DATE: September 4, 2015  
TO: Tujia Catalano, Reuben, Junius & Rose, LLP  
FROM: Ms. Joy Navarrete, Planning Department  
RE: PPA Case No. 2015-002325 for 48 Tehama Street

## Preliminary Project Assessment

*Date:* September 4, 2015  
*Case No.:* **2015.002325PPA**  
*Project Address:* 48 Tehama Street/543 Howard Street  
*Block/Lot:* 3736/084, 085, & 111  
*Zoning:* C-3-0(SD)  
Transbay C3  
Transit Center C-3-0(SD) Commercial  
350-S  
*Area Plan:* Transit Center District Plan (TCDP)  
*Project Sponsor:* Tujia Catalano  
415.567.9000  
*Staff Contact:* Rachel A. Schuett – 415.575.9030  
[rachel.schuett@sfgov.org](mailto:rachel.schuett@sfgov.org)

Title: CASE No.2015-002325PPA  
Comments: Modeled at 370 feet height approx - flat surroundings  
(includes allowance for 20' mech.screening in C-3 Districts)  
Printed: 15 April, 2015

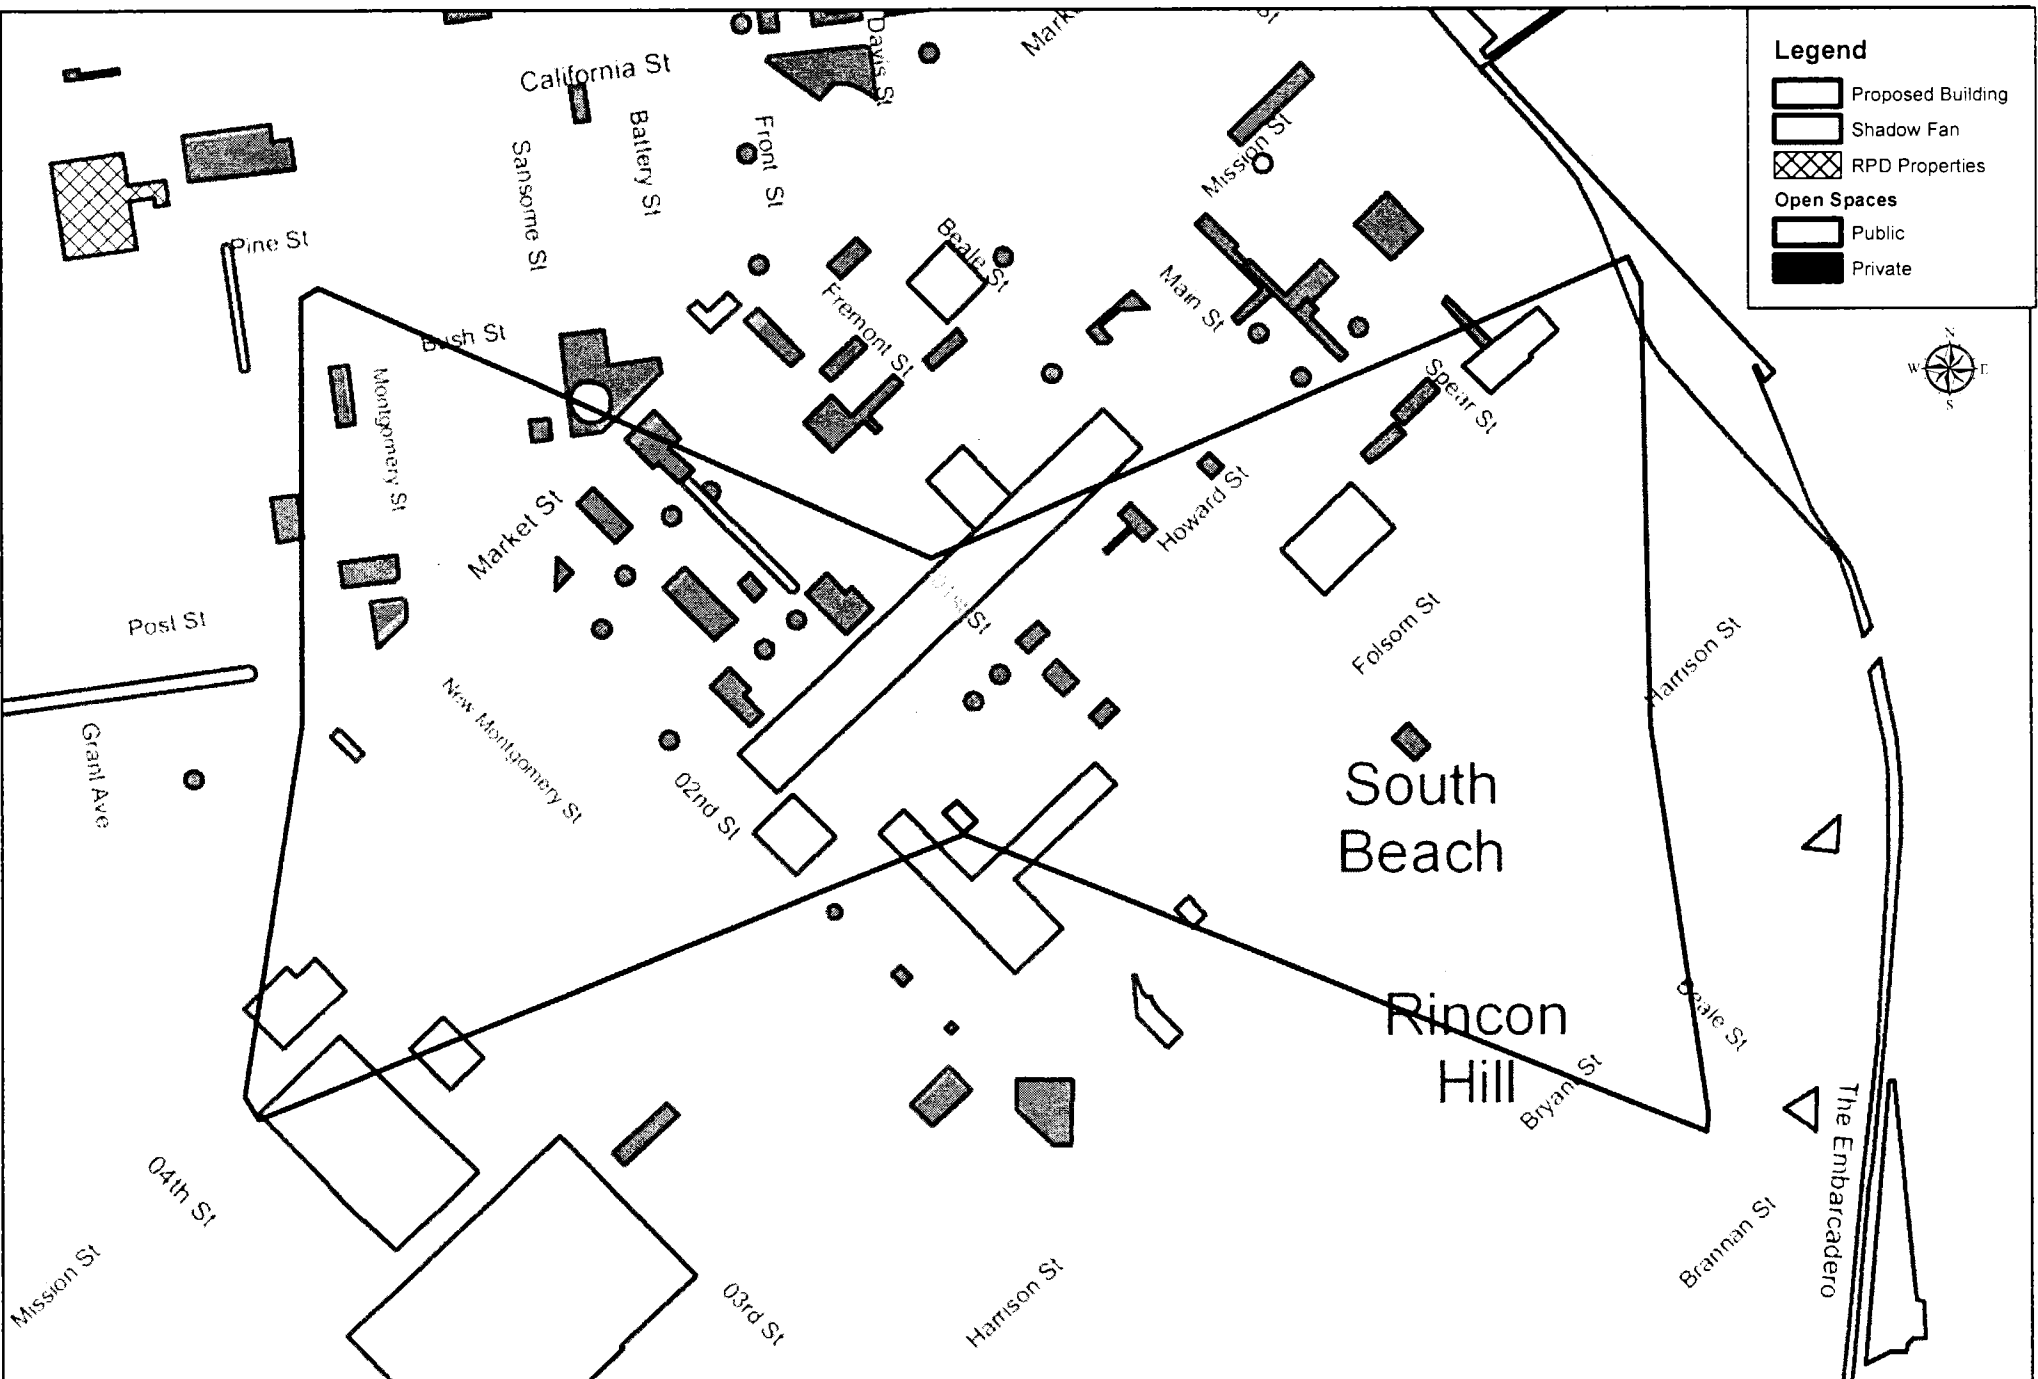
- **Shadow.** The proposed project would result in construction of a building greater than 40 feet in height. A preliminary shadow fan analysis prepared by Planning Department staff indicates that the proposed project could cast shadows on several parks and opens spaces that are not under the jurisdiction of the Recreation and Park Department. For more information, see "Preliminary Project Comments" below. The project sponsor is therefore required to hire a qualified consultant to prepare a detailed shadow study. The consultant must submit a Shadow Study Application, which can be found on the Planning Department's website (<http://www.sf-planning.org/Modules/ShowDocument.aspx?documentid=539>). A separate fee is required. The consultant must also prepare a proposed scope of work for review and approval by Environmental Planning staff prior to preparing the analysis.

10. **Shadow Analysis (Section 147).** Section 147 requires that new buildings and additions to existing buildings in C-3-O(SD) District that exceed 50 feet shall be shaped to reduce substantial shadow impacts on public plazas and other publicly accessible spaces other than those protected under Section 295. A preliminary shadow study was conducted by Staff in conjunction with this PPA Application, and it indicated that the project will not cast a shadow on any park or open space protected under Planning Code Section 295. Department staff has prepared a shadow fan that indicates the project may cast new shadow on multiple public open spaces. Therefore, a detailed

shadow analysis would need to be prepared to determine if the project would create new shadow that results in an adverse impact to these spaces, pursuant to Section 147. If this detailed shadow analysis finds that the project would cast shadow on public open space, the sponsor should explore sculpting of portions of the project to avoid casting new shadows on the open space.
